**FINAL
ENVIRONMENTAL IMPACT REPORT**

**DEL PASO REGIONAL PARK MASTER PLAN
IMPLEMENTATION PROGRAM**

**SCH# 84091704
JANUARY 1985**

SUBJECT: Final EIR for the Del Paso Regional Park Master Plan Implementation Program

EXHIBIT B-3. SPORTS COMPLEX ALTERNATIVE 1 (REVISED)

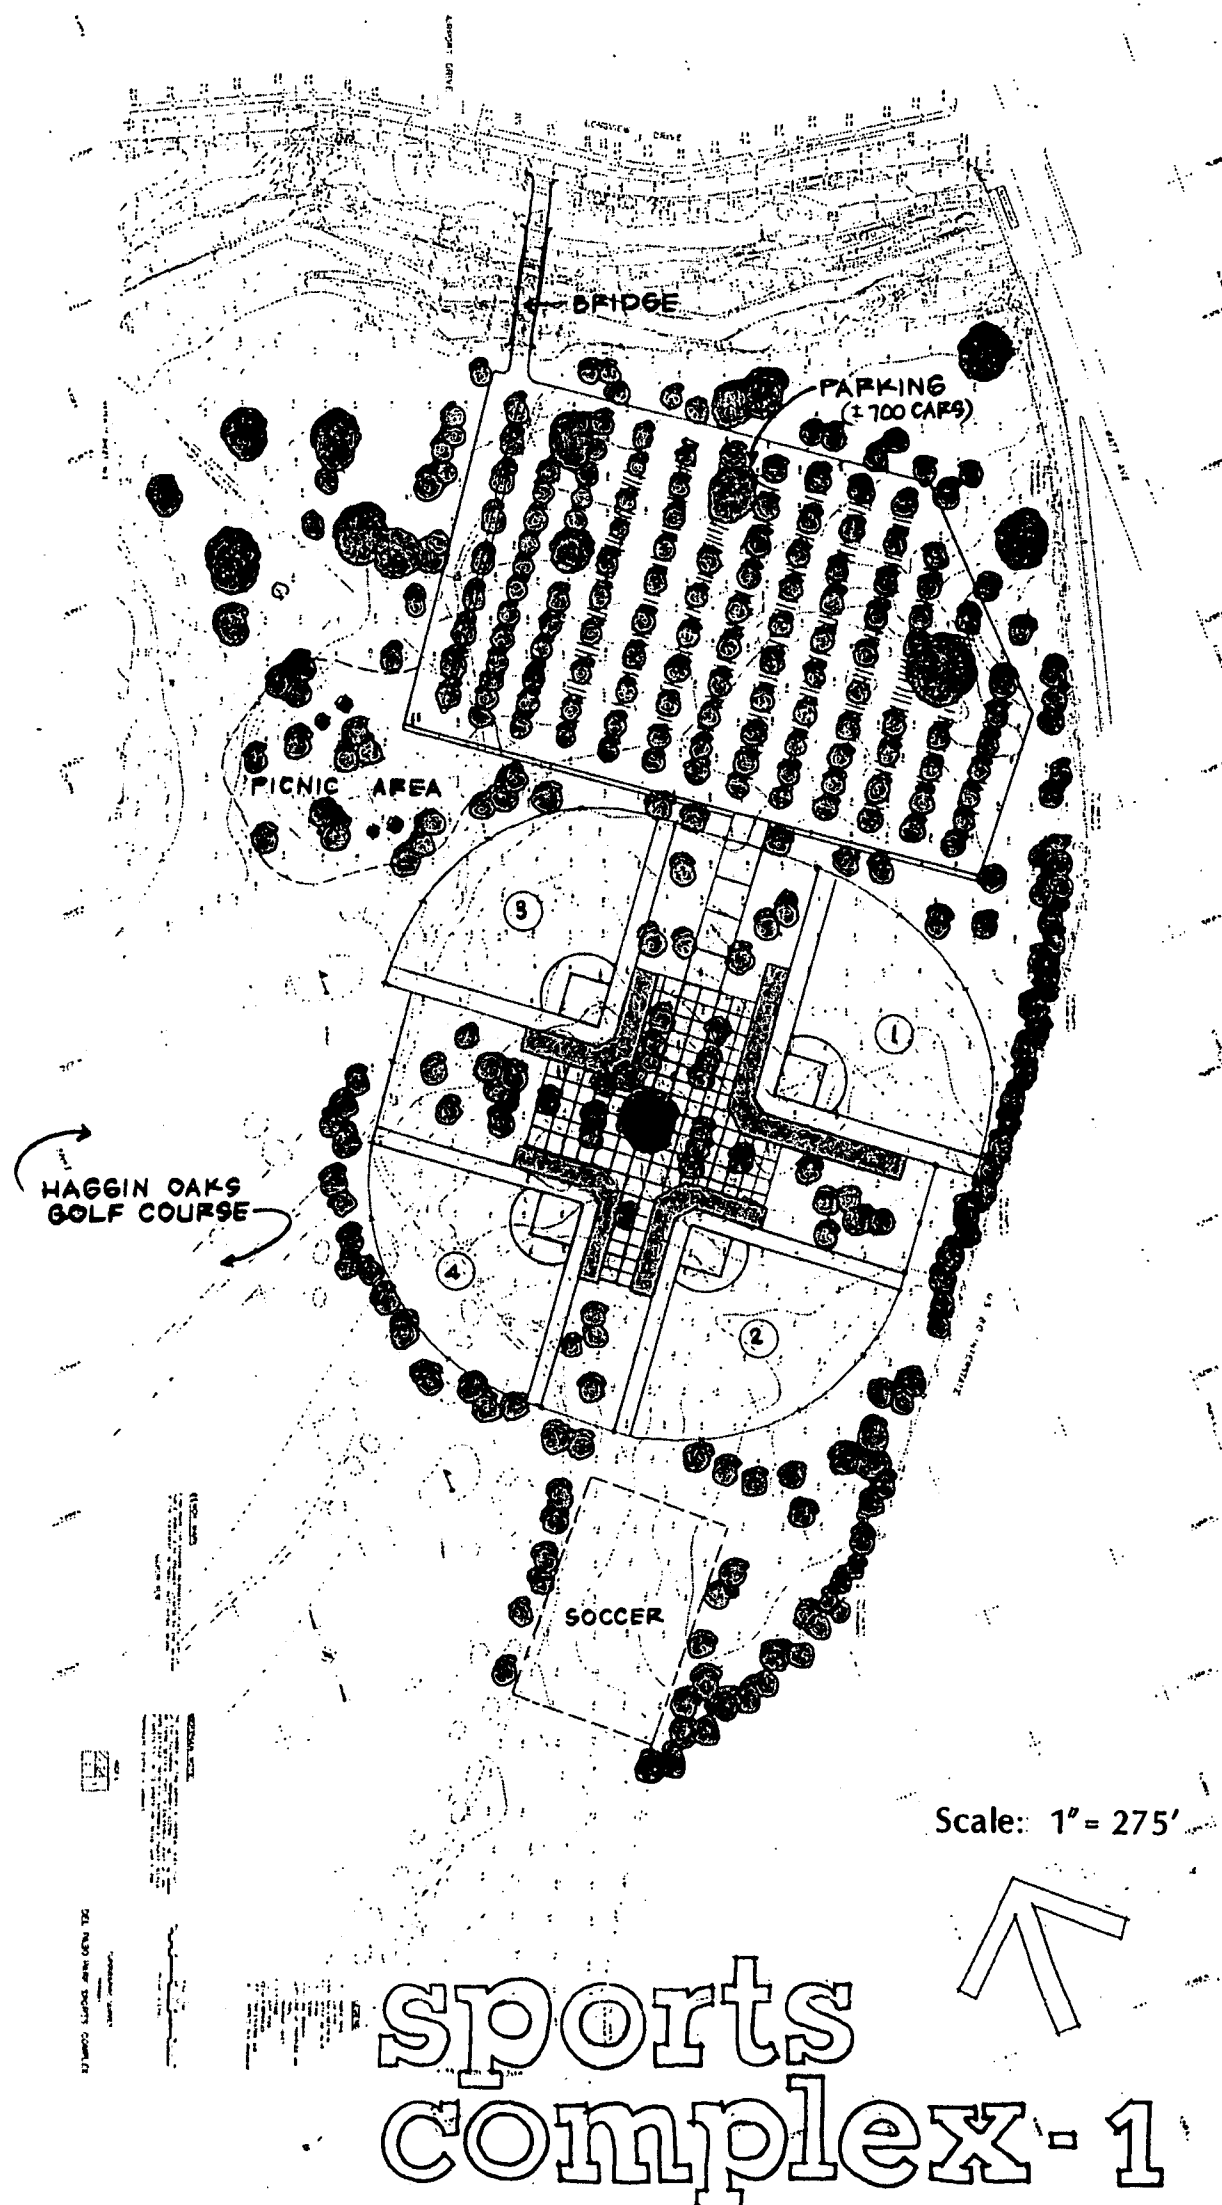
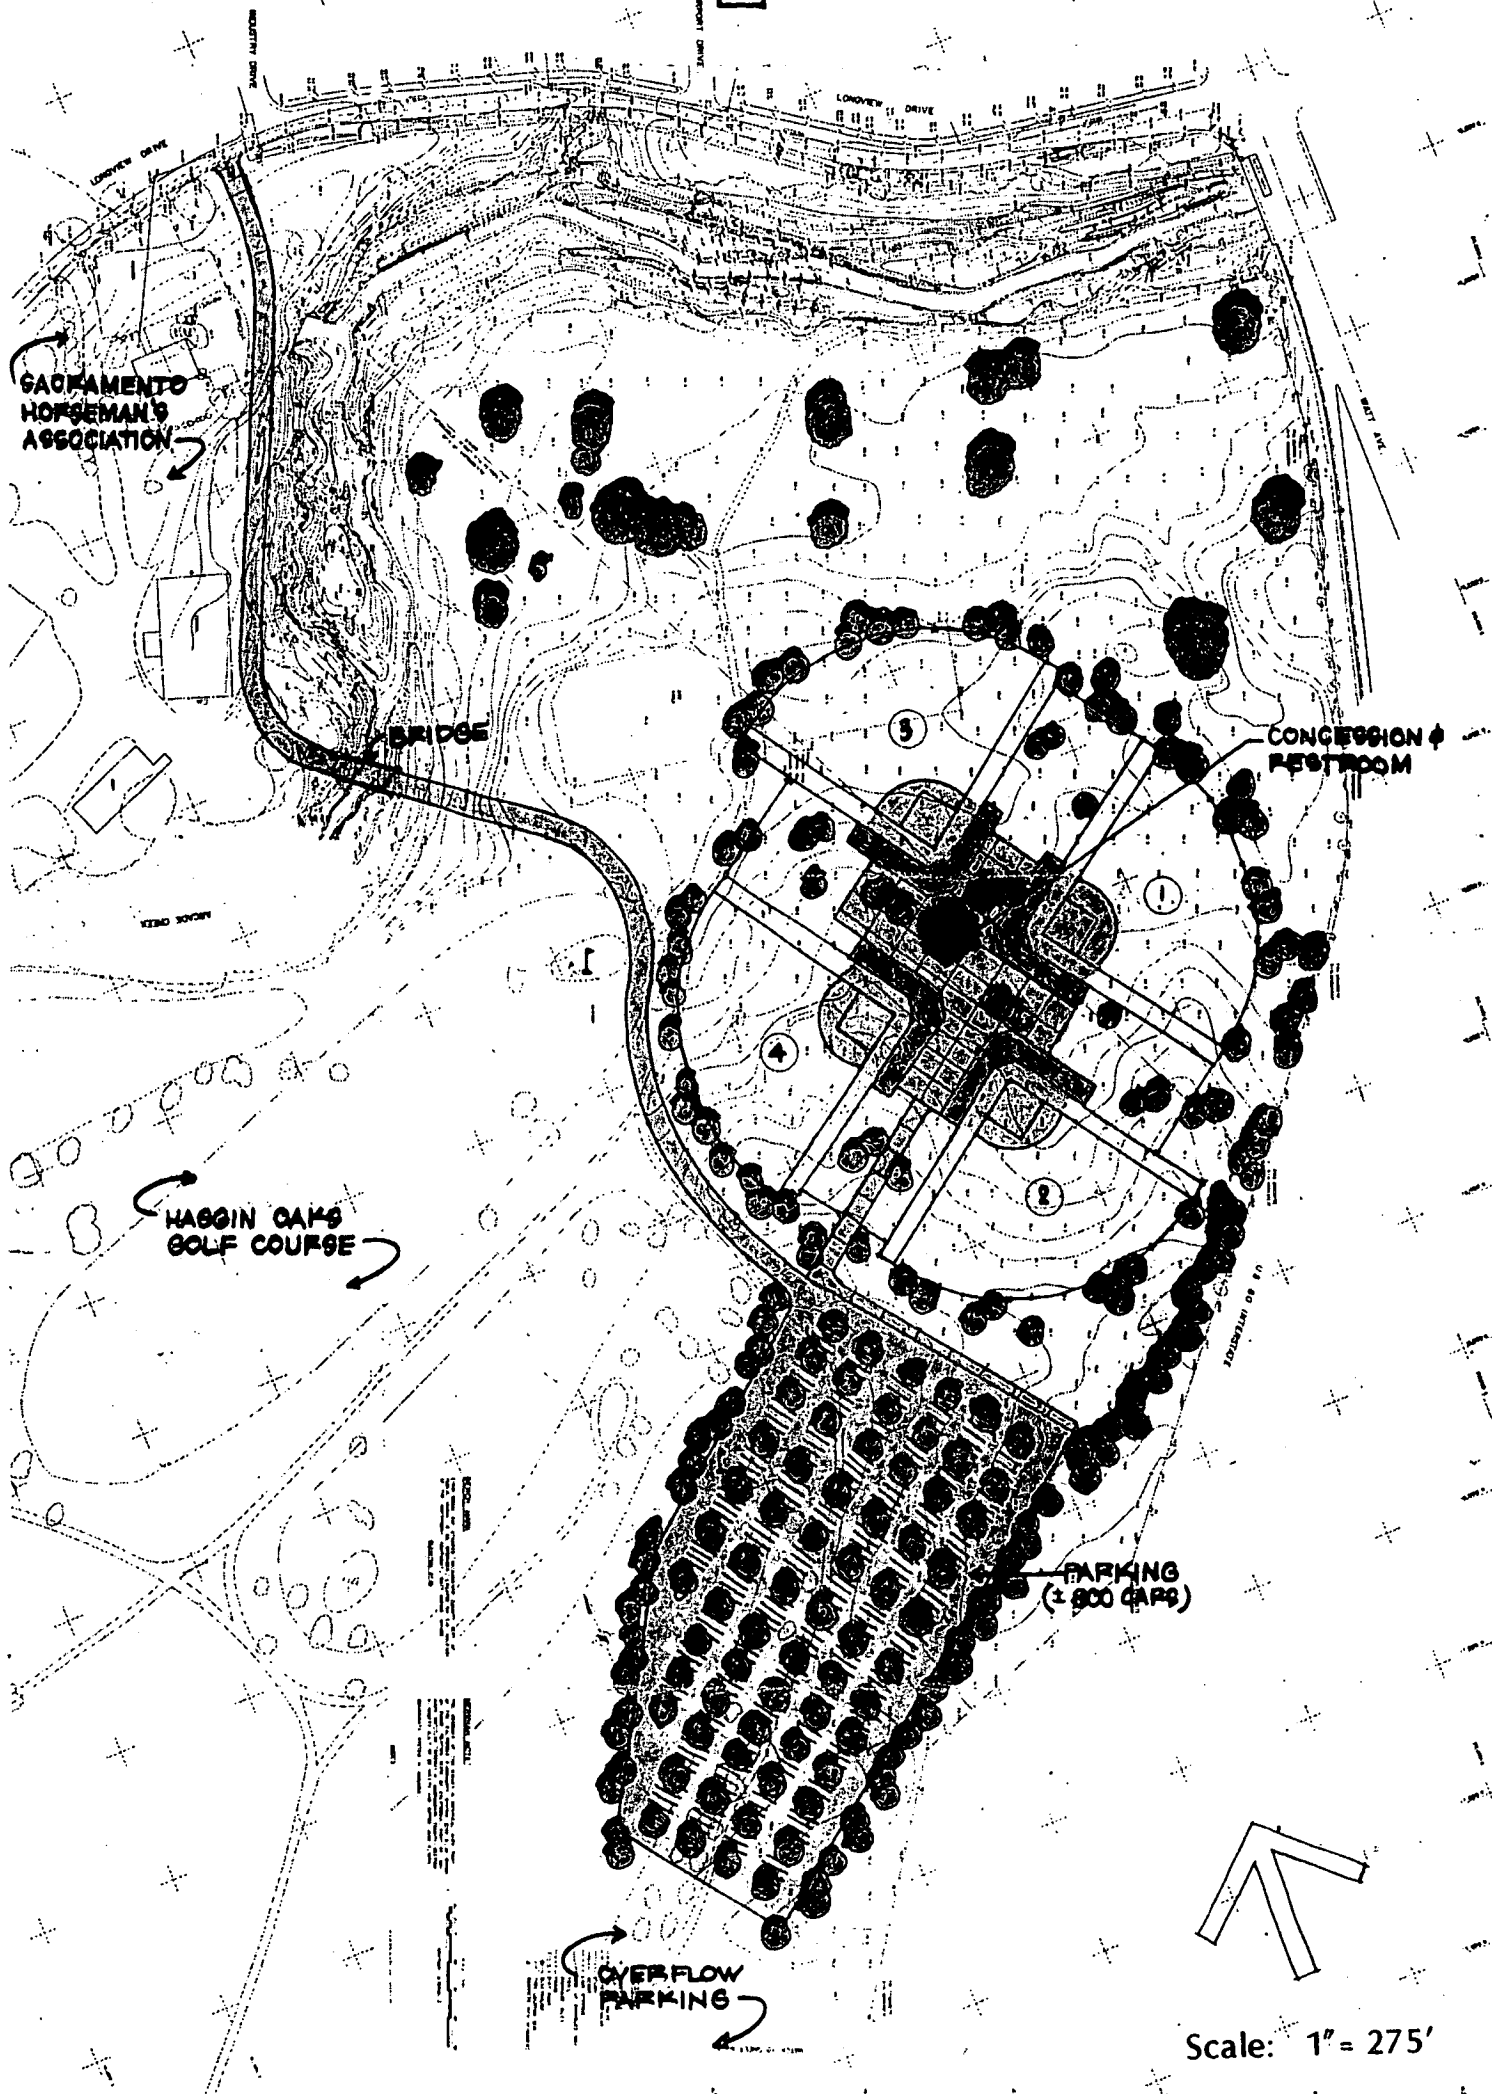
Comment: The City of Sacramento did offer two alternatives to their softball complex but their drawings were so grossly inaccurate and their scale so questionable they could not be analyzed. Possibly as a result of these bad data inputted to Jones and Stokes the Draft EIR is so inadequate in the opinion of ACRP that it cannot be salvaged without a major rewriting.

Comment: Maps of Alts 1, 2 and 3 are presented on pages 10, 11 and 12. These maps are drawn on different scales and with different orientations. In order to compare the impacts of different configurations of the sports complex, parking lot and access route, the final EIR must present maps of the 3 alternatives using the same scale of orientation. Moreover, the maps presented on p. 10-12 are inaccurate. The Final EIR must contain maps based on the land survey conducted by the city and

Response: When the DEIR was prepared, the consultant relied on the only maps that were available. The consultant was aware that these maps were not to scale, but the City felt that a meaningful analysis could nevertheless be performed since potential impacts could be identified without more detailed maps. During the public review period, more detailed maps of the alternatives were prepared (see revised Exhibits B-3, B-4, B-5).

Response: Revised maps of the sports complex alternatives (at the same scale) have been prepared (see revised Exhibits B-3, B-4, and B-5 in Section 2, Key Revisions of this FEIR). In addition, base maps of the park showing existing environmental constraints have been prepared (see Exhibits 2-2 and 2-3).

Comment: EXHIBIT B-4, B-5. These two figures need to be substantially upgraded. EXHIBIT B-4 softball fields should be offset such that the athletic complex is south of the vernal

Comment: Impact, elimination of soccer fields, Sports Complex-2. The soccer field would not have to be eliminated if fairway #13 of Haggin Oaks Golf Course was moved 200 ft into a 400 ft rough area separating it from fairway #14. This could be accomplished even if the softball fields were set further south than is shown in EXHIBIT B-4. (Steve Talley for ACRP)

Response: See response to Comment F-25A. The access road B as shown in revised Exhibit B-4 will avoid the large oaks in the northwestern corner of the terrace, but would probably remove some oaks and other vegetation at the stream crossing.

Comment: EXHIBIT B-5 (Alt. 3) should also receive accurate updates respecting position of the access route (the Nov. 21, 1984 route should be used) and natural habitat features. This plan could be made more environmentally sensitive by moving the parking lot to the south of the fields and running the access route parallel to the Business 80 right of way. Alternatively two 200 car lots could be put at either end. In either case there is sufficient space for overflow parking at the southwest end of the complex. City staff should seriously try to upgrade the quality of this plan as along these guidelines. The only real disadvantage is that space for a soccer field would not be available. (Steve Talley for ACRP)
